Imray Correction Notice IC2800-3

Chart 2800 WGS 84

Edition 2021

Block correction for 2800 Tidal streams
around the north of Jura
ILNW 184/22

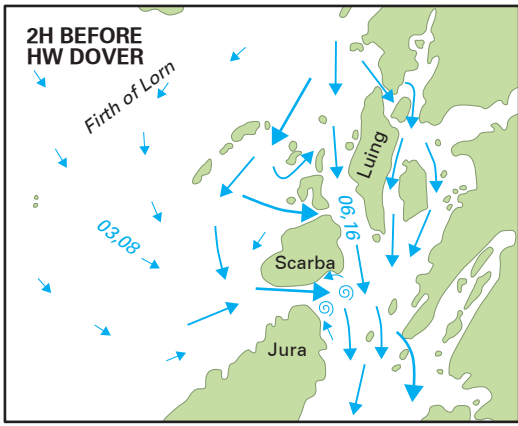
3 Tidal streams around the north of Jura (*certain copies*)

Insert block correction tidal stream diagram around Jura 2H Before HW Dover replacing the duplicate 1H Before HW Dover diagram (ILNW 184/22)
